Final Drainage Report – Filing No. 1

Waterview East Commercial El Paso County, Colorado

Add text:
EDARP File No.:
SF269

DETENTION BASIN OUTLET STRUCTURE DESIGN

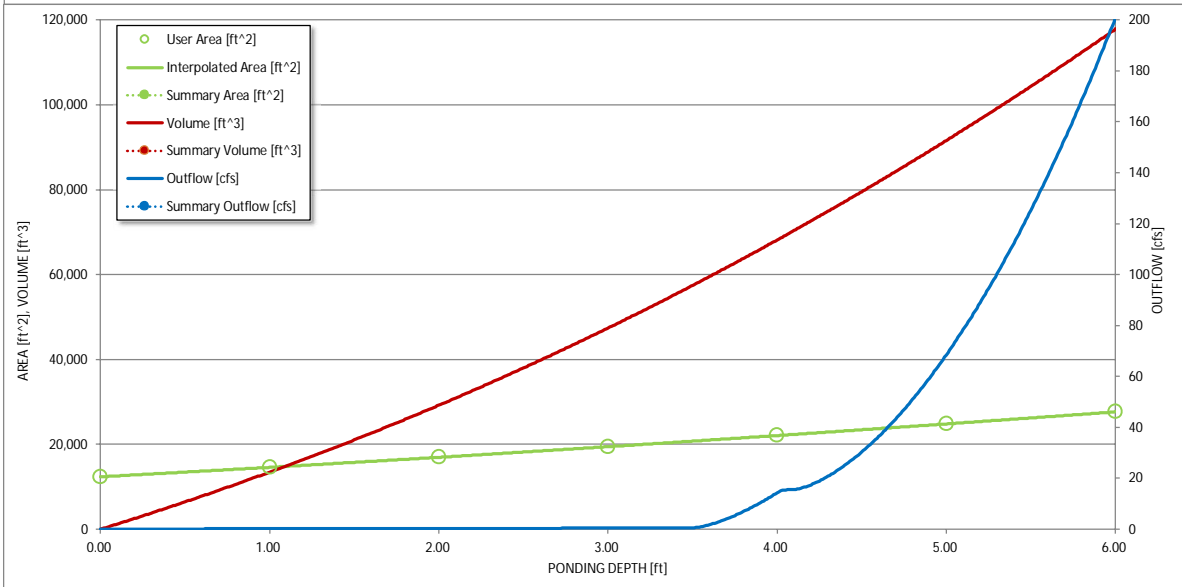
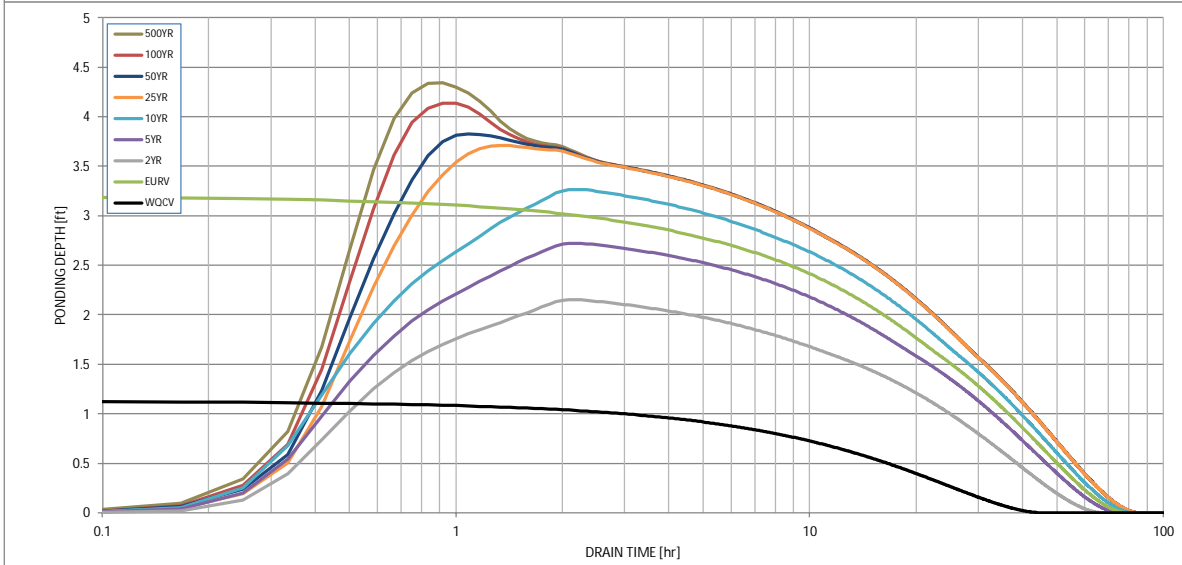
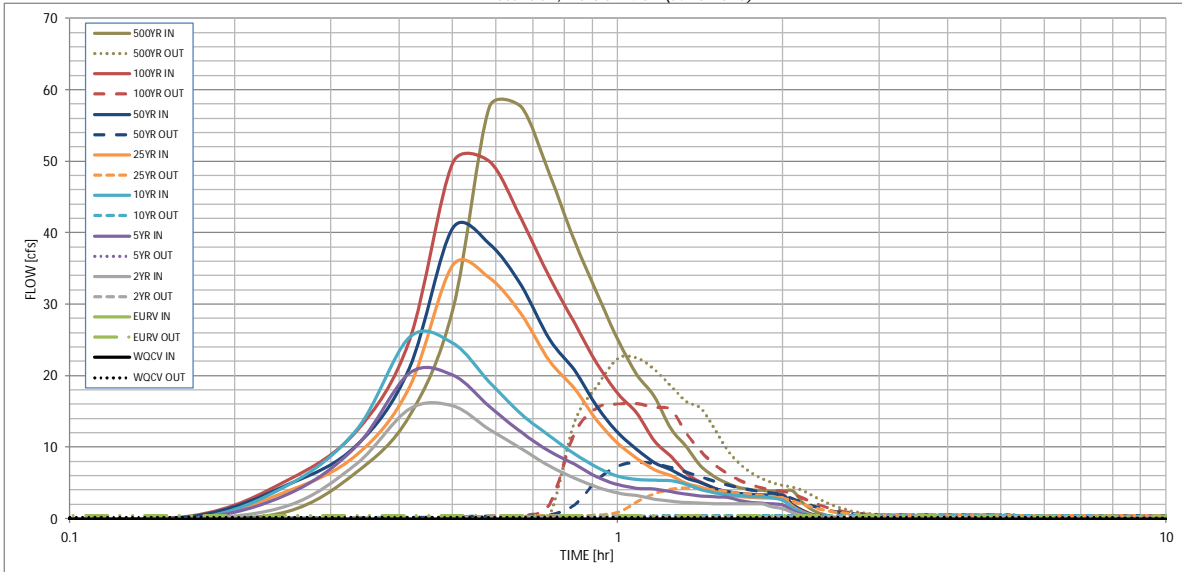
based on my comments on Sht C4.15 in the GEC Plans, these depths/elevations do not match what is shown on the plans.

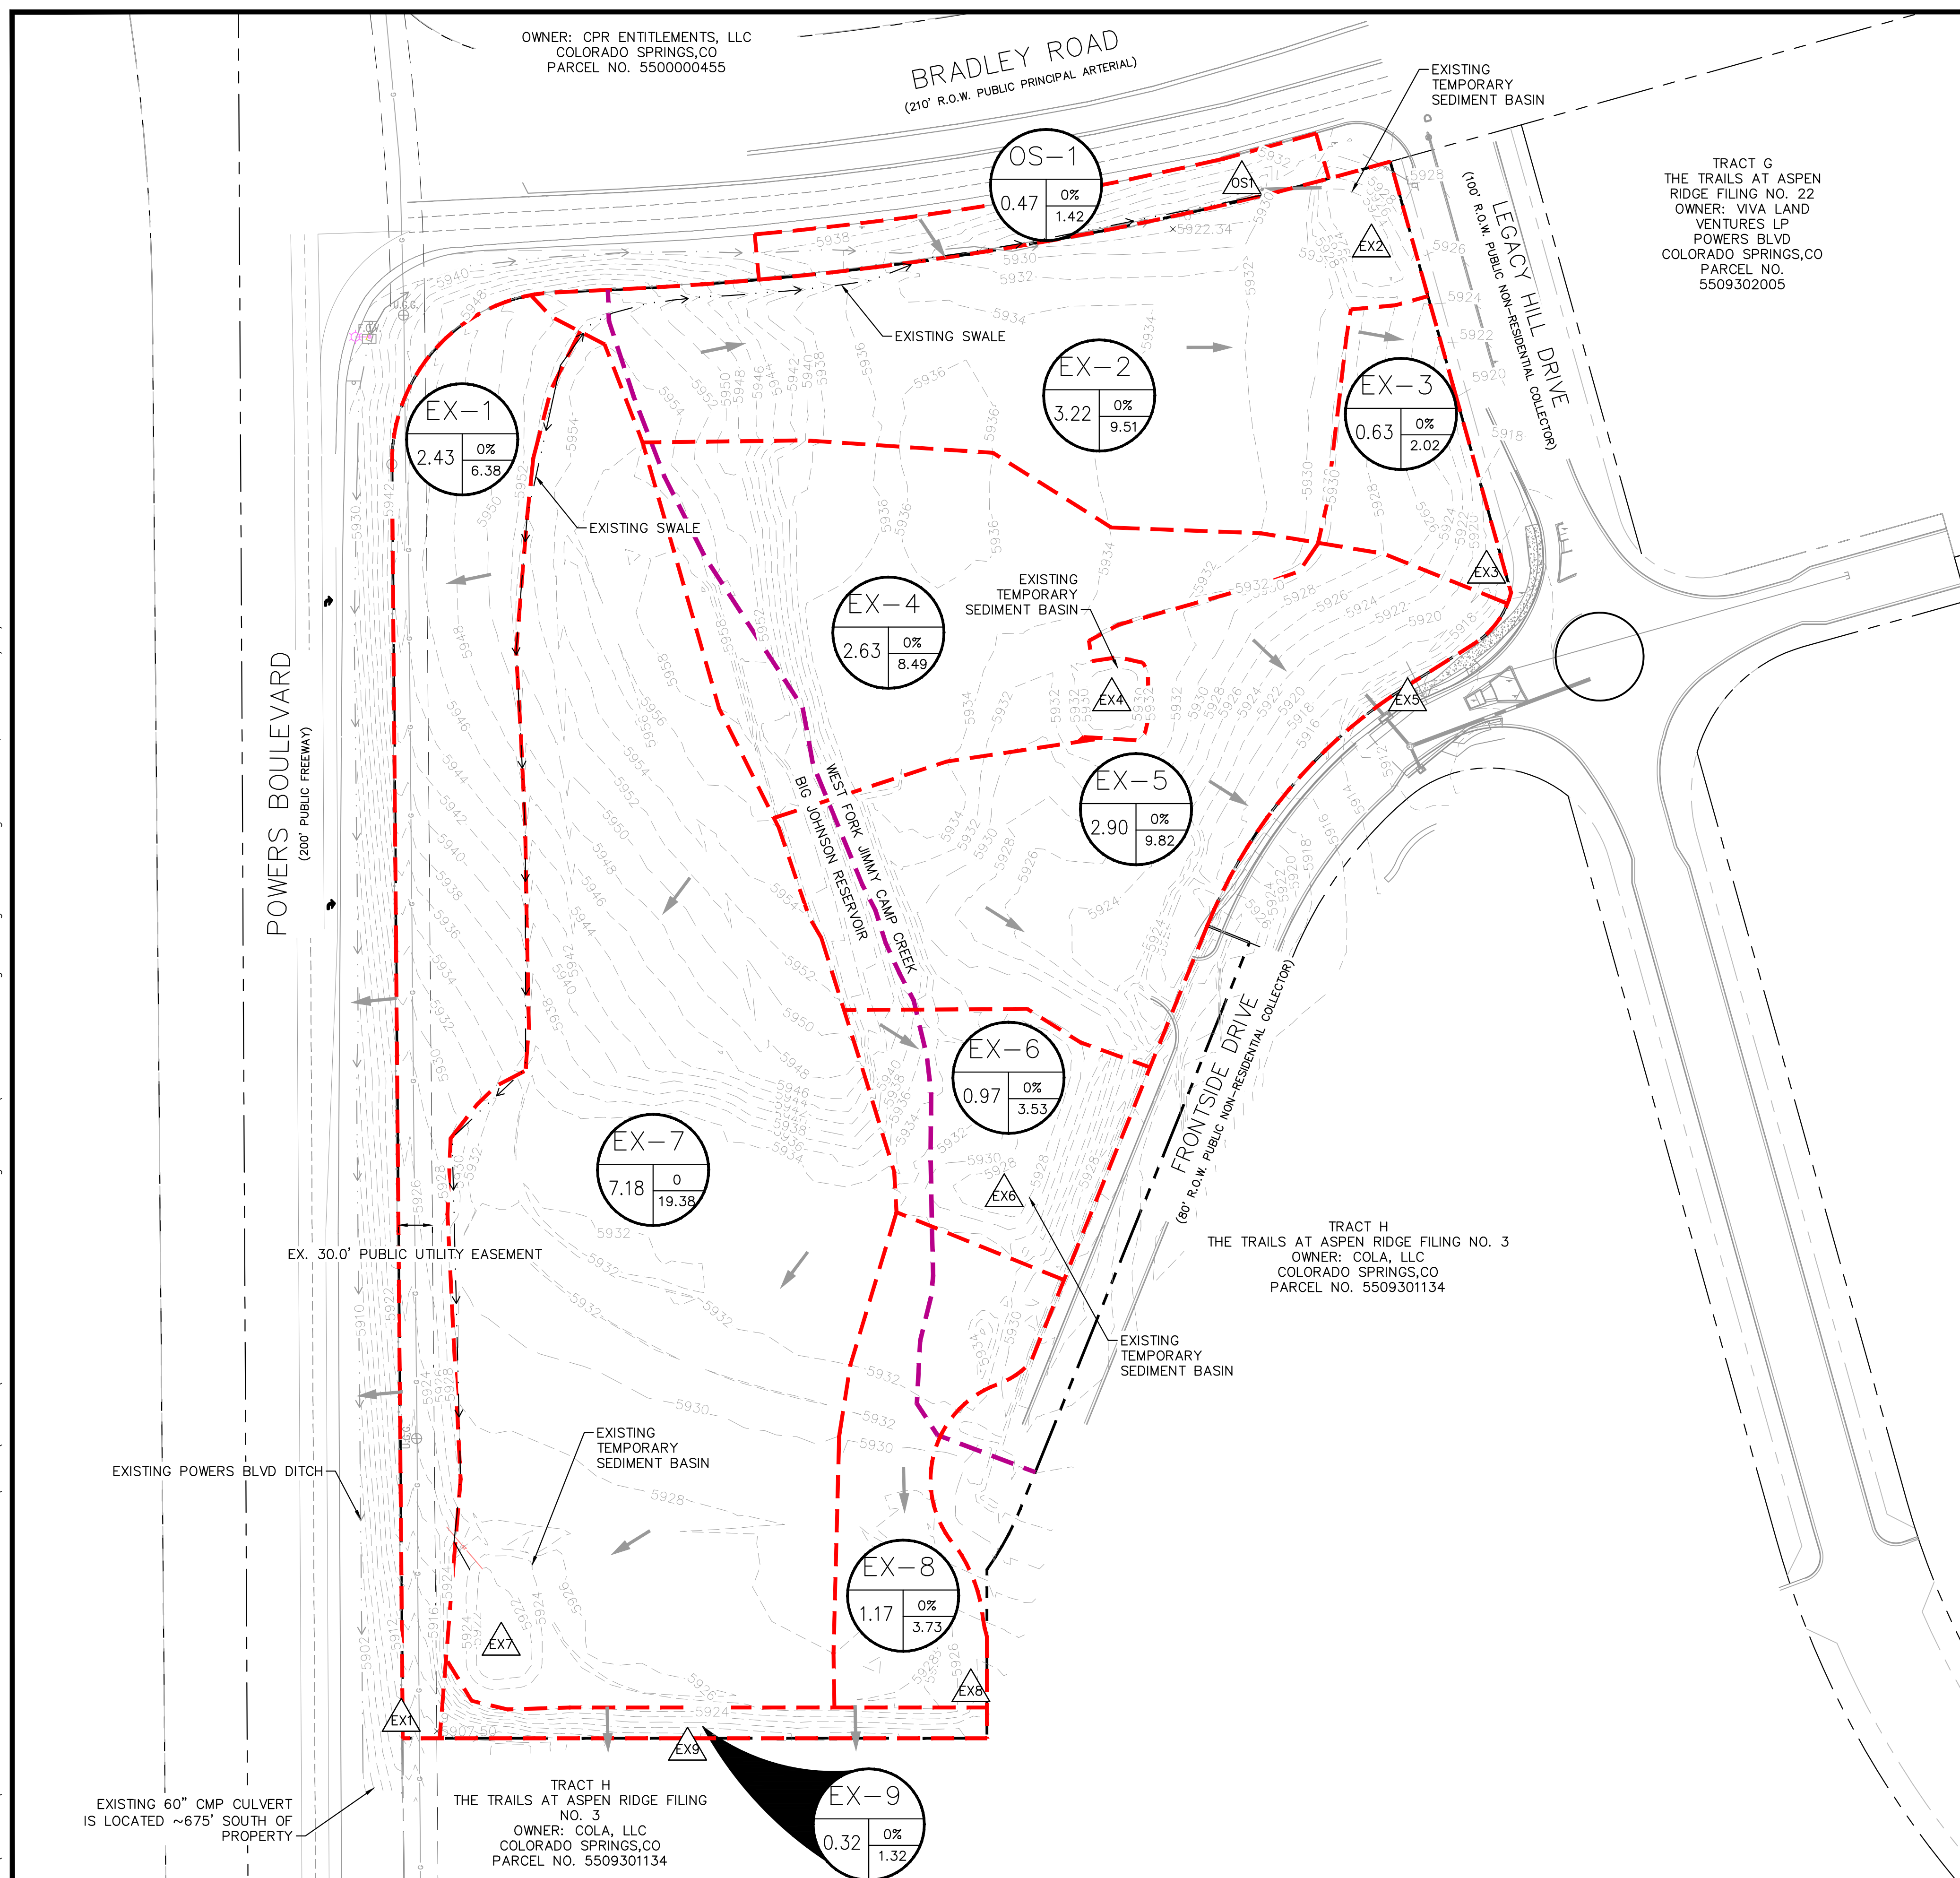
I dont understand how basins FD 1 and FD 2 can span across two major drainage basins (ie the purple line), when there is no proposed grading shown that would show flows being transferred from Big Johnson DB to JCC DB. I also dont think we allow such transfers (but that's not really my purview, talk to Charlene about this). Your PBMP Summary Table below shows FD 1 and FD 2 as being treated by Pond P, but everything west of the purple line will not flow to that pond. So please address this design issue throughout this report.
